Tel-Aviv. September 08, 2009

Piezo DC sirens problems for June until August 2009 shipments

How to power sirens from battery

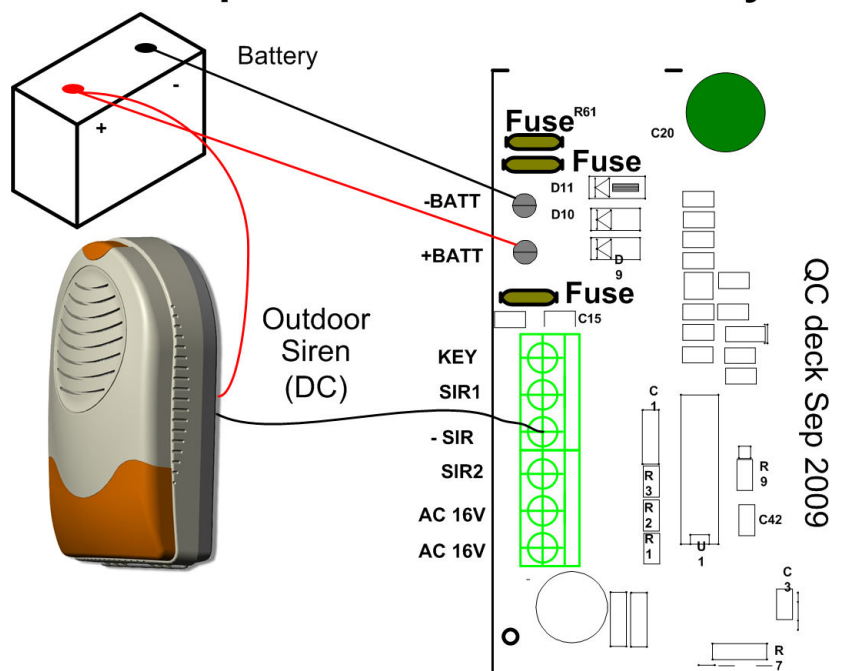
- When powering up the dial LED is off, or keypad is off
- Few or most panel zones are not functioning
- Dialing to accounts, but the siren sound not generated

Such problems caused only when using DC Piezo sirens, by now this issue solved in our production line. If you face any strange trouble try to disconnect the siren/s first.

To bypass the problem: Power off the panel, remove the +SIR wire terminal in the panel, wire the positive siren/s lead/s directly to the battery positive terminal.

Keep the negative siren lead wired to -SIR at panel. Please do so for both internal and external sirens.

To prevent problem caused by DC sirens ,connect the Positive Siren/s lead/s directly to + battery
